MODIFICATION SHEET NO. RDSO/2014/EL/MS/429, Rev.'0' Dated 26.02.14

- 1.0 **Title:**
Modification sheet for avoiding necessity of cab changing in case of failure of processor cards of VCU of WAG9/WAG9H three phase locomotives.

Annexure-I/2

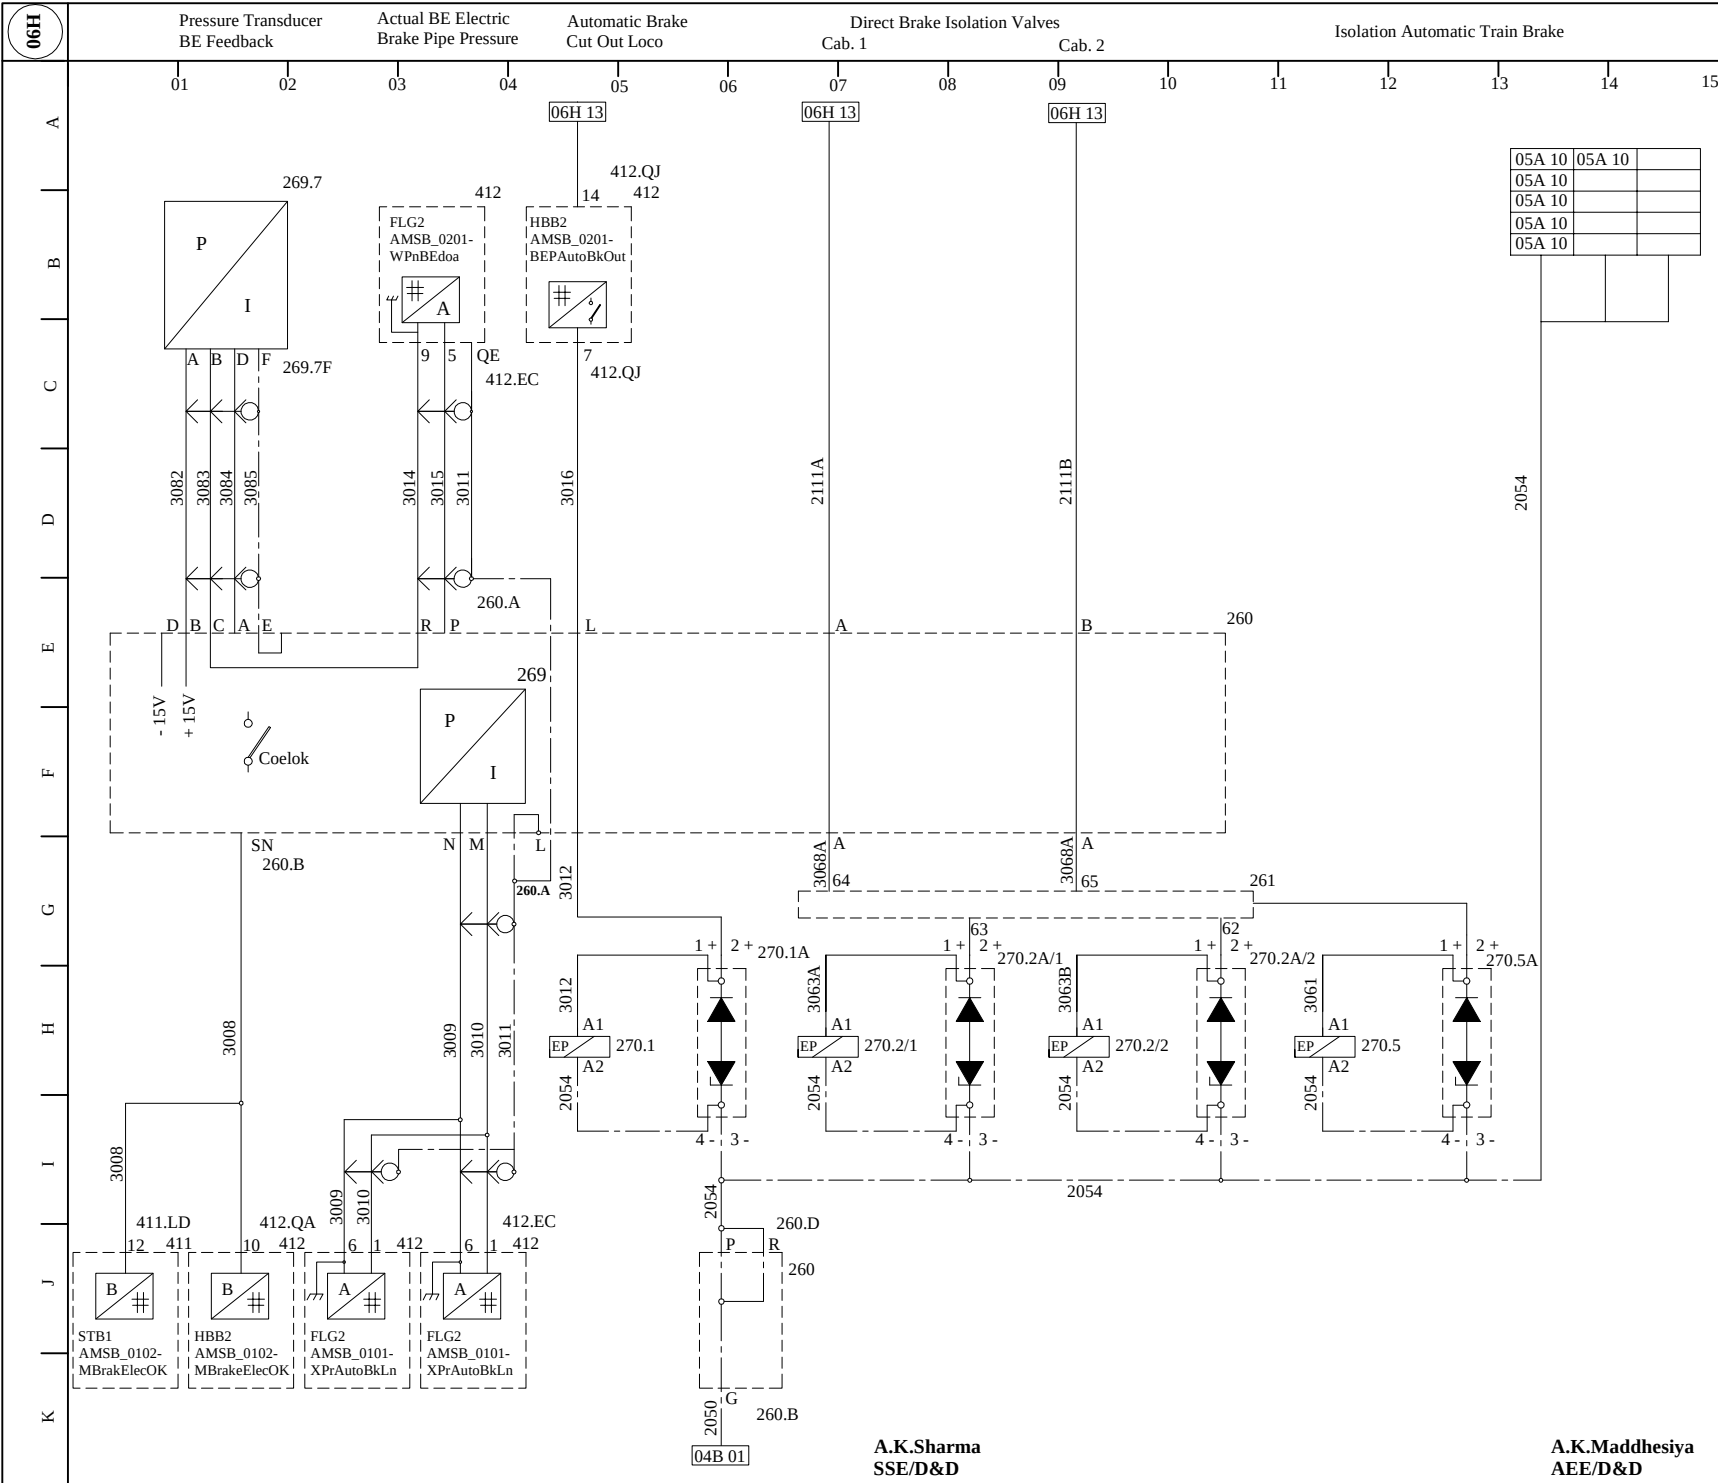
- 4.0 **Modified Arrangement to replace existing arrangement as given above in 3.0:**
The modified arrangement of wiring for the input/output signals with related processors for WAG9/WAG9H is given in Annexure-I with red colour along with wiring details.

VCU Redundancy for WAG9 and WAG9H

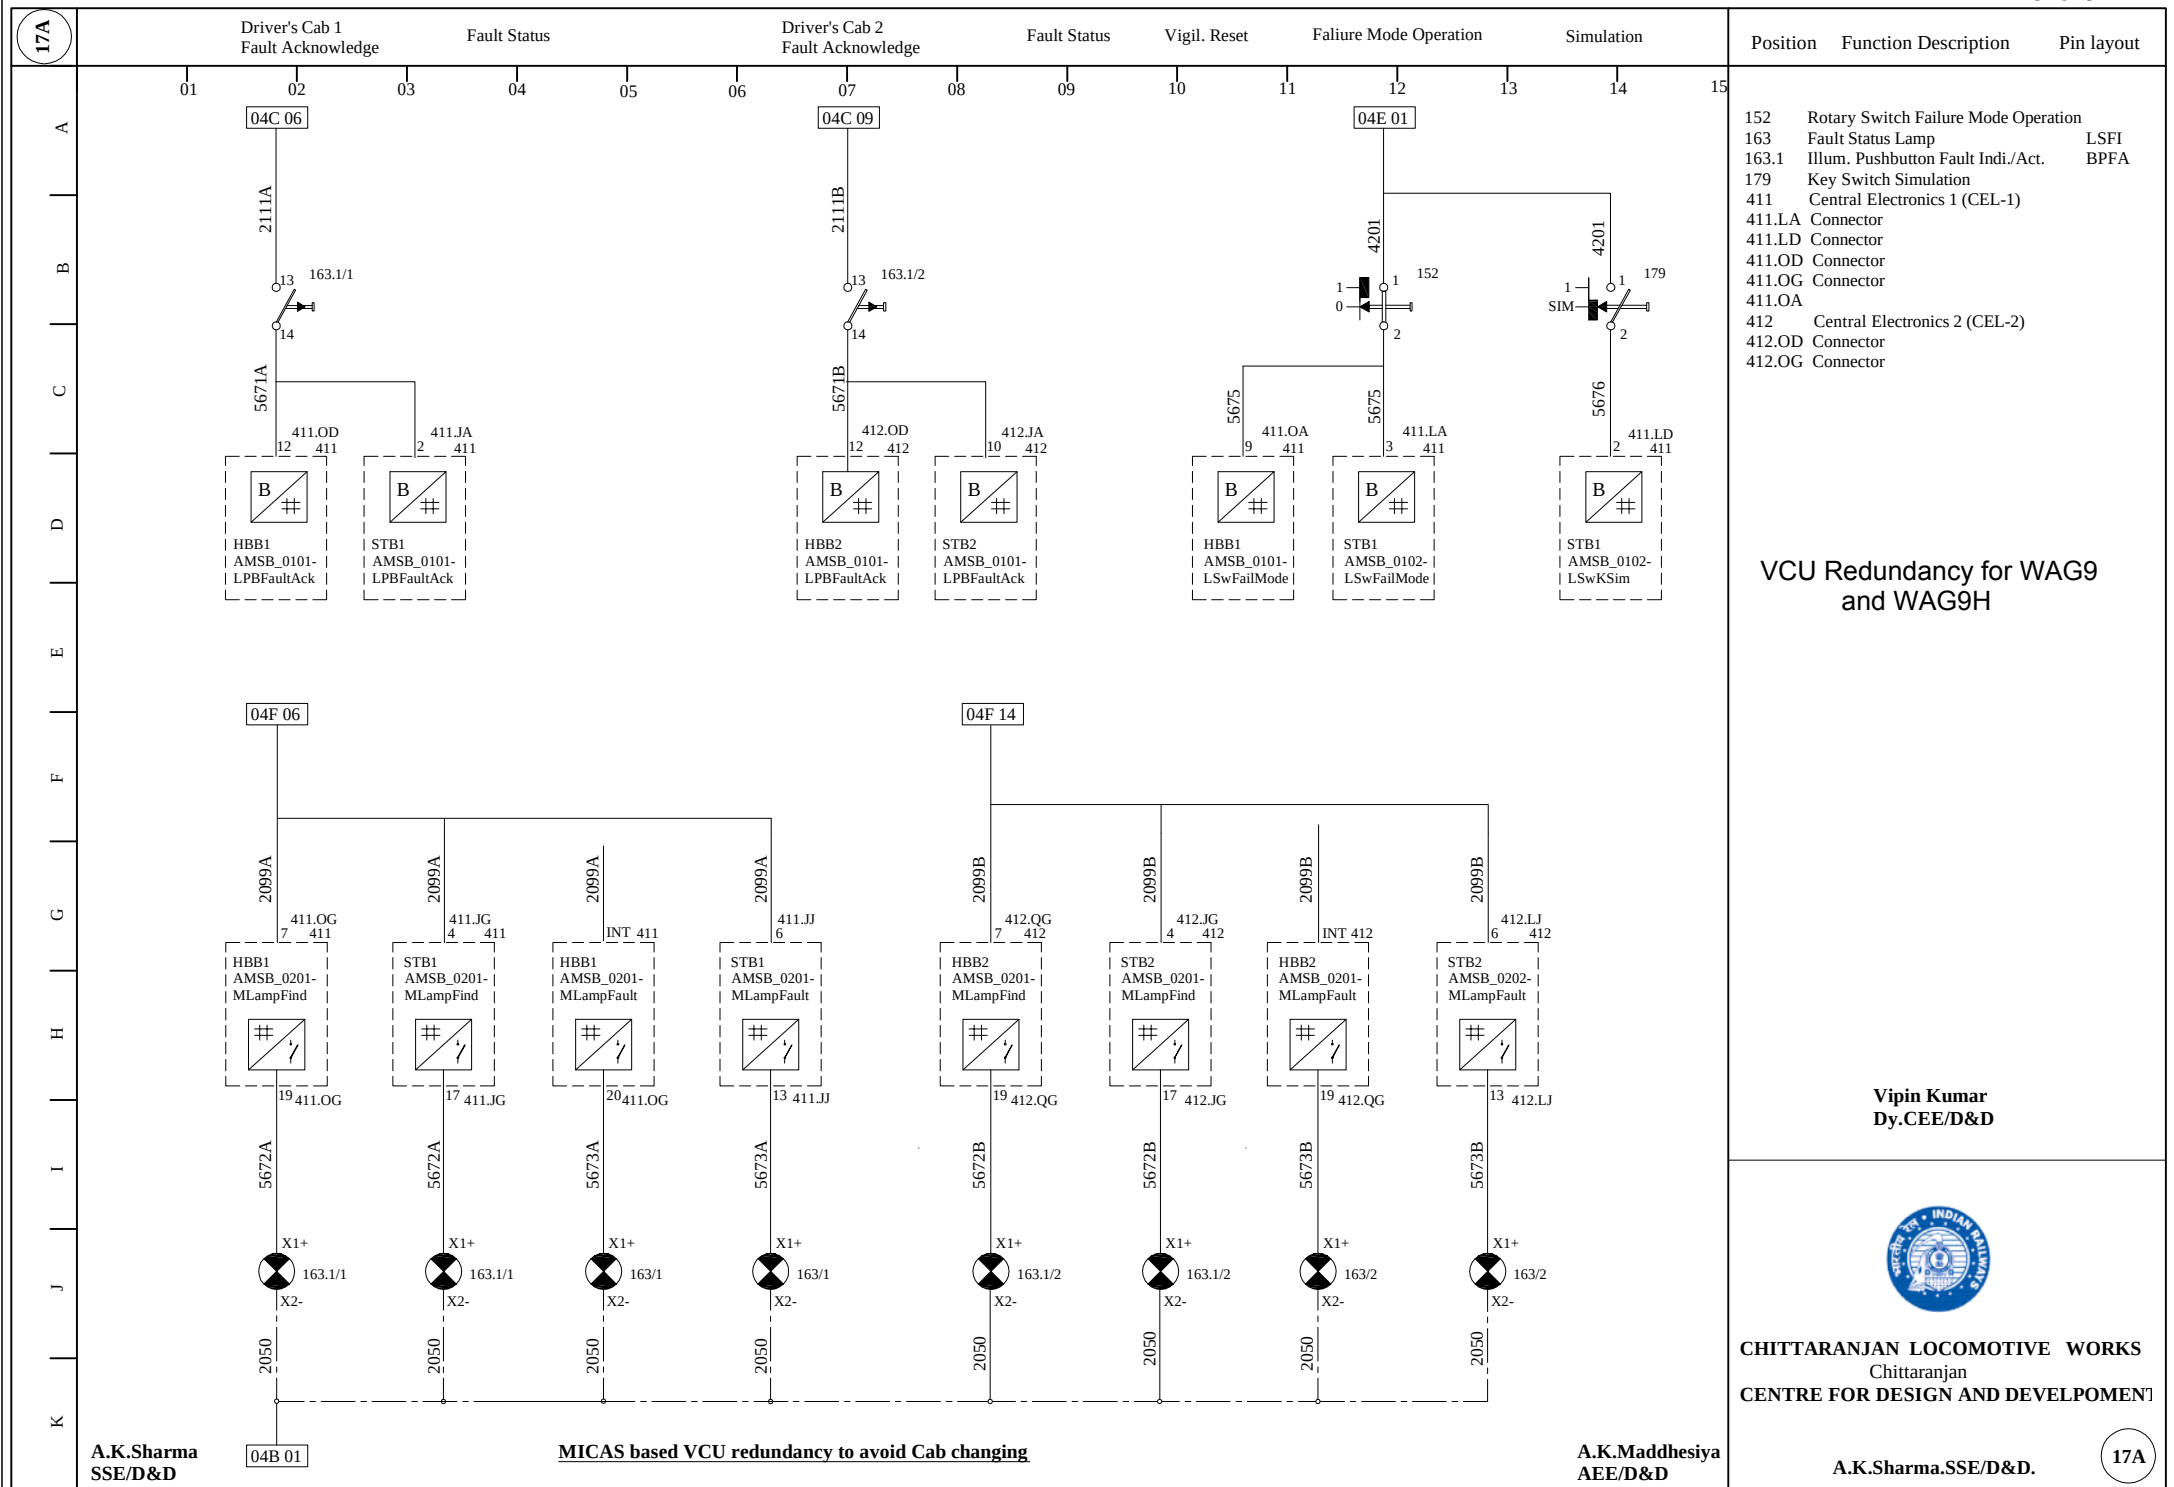
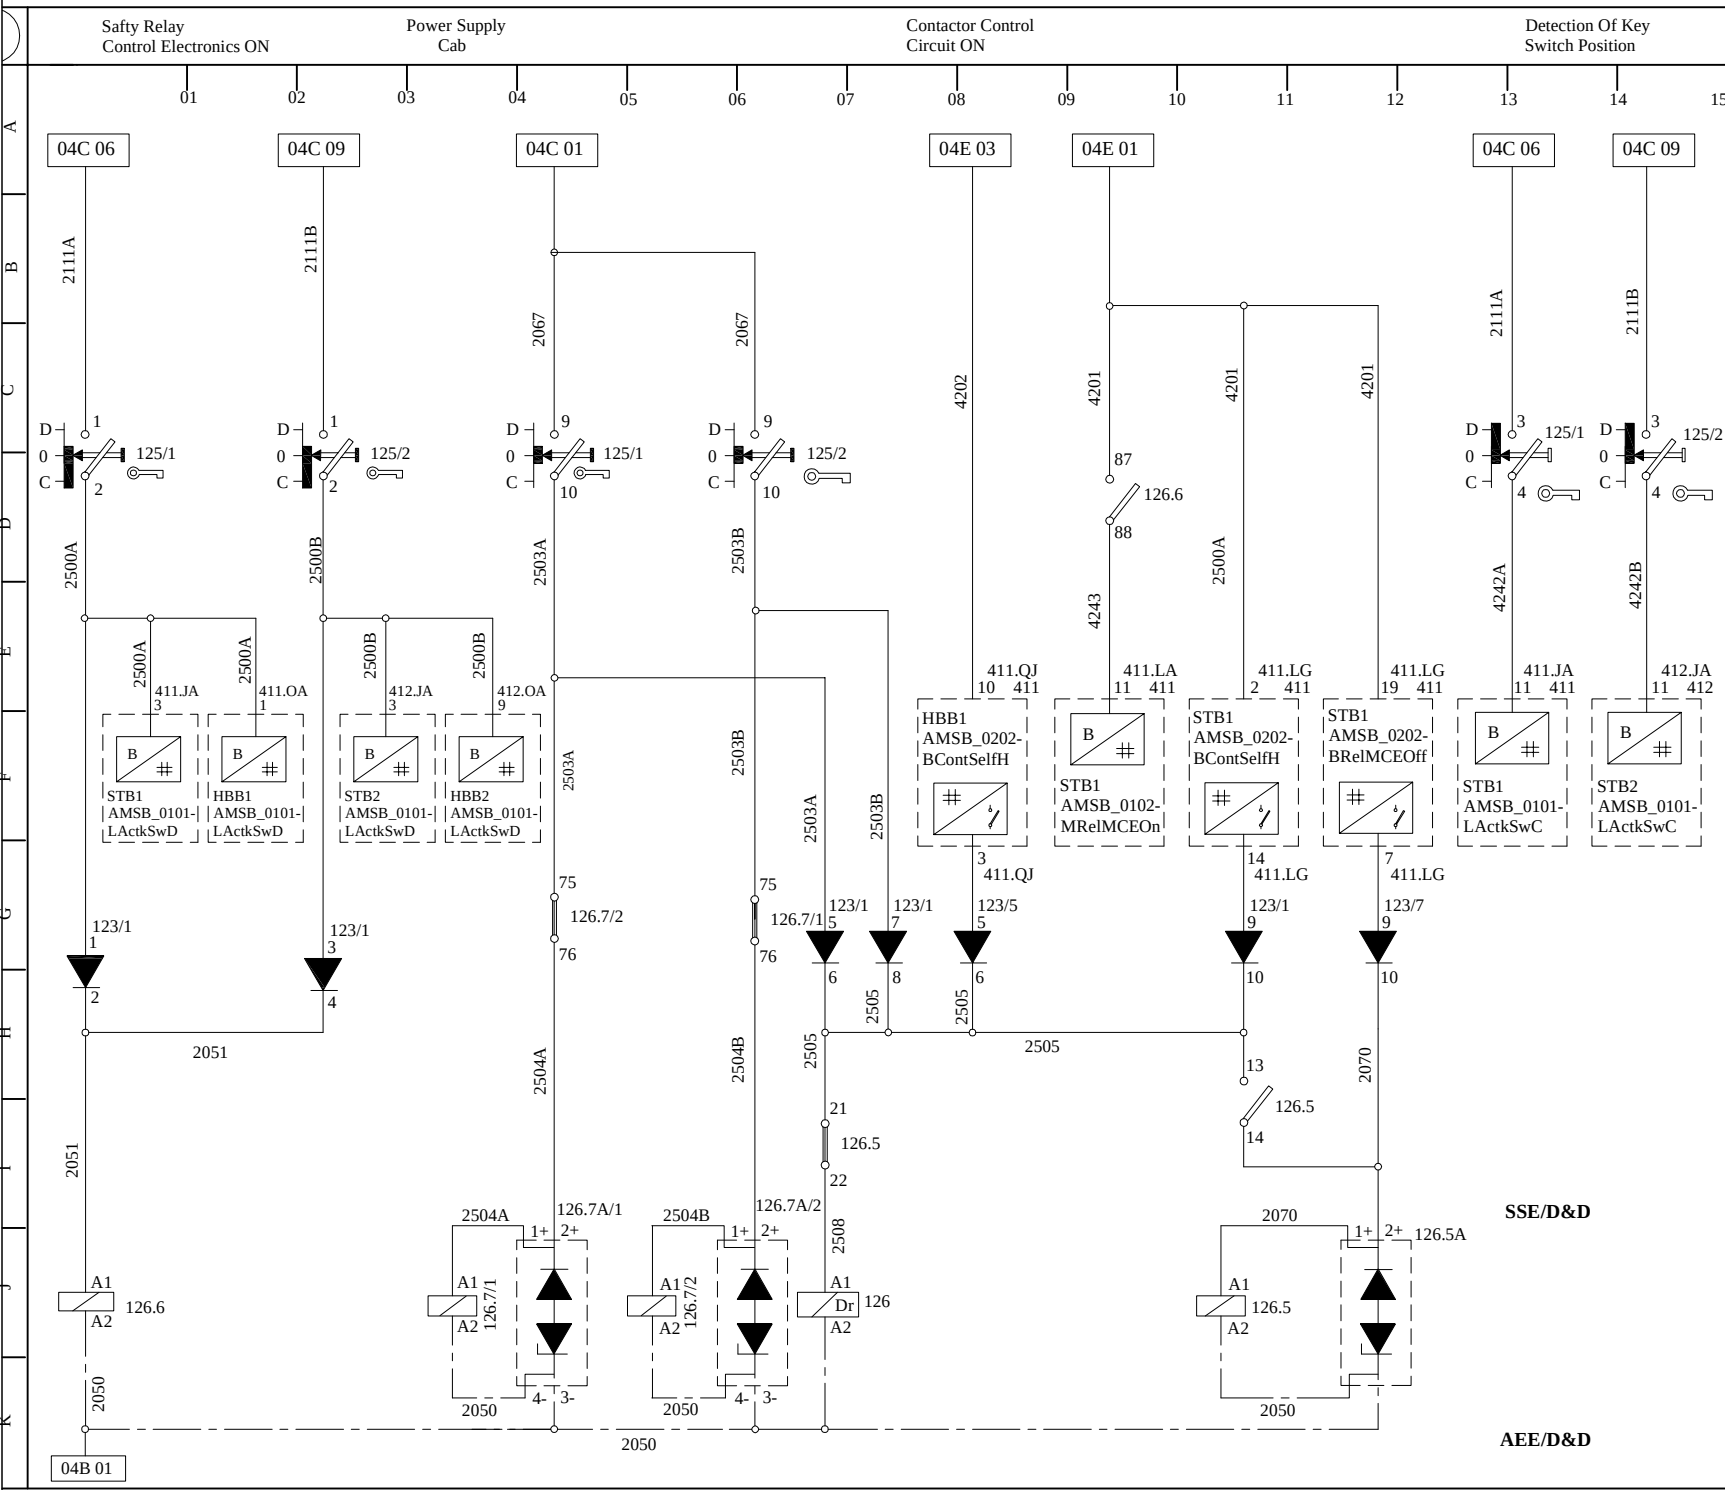
- 3.0 **Existing Arrangement with cross-references of respective design document:**
The existing arrangement of wiring for the input/output signals with related processors is given in Annexure-I for WAG9/WAG9H locomotive with green colour.
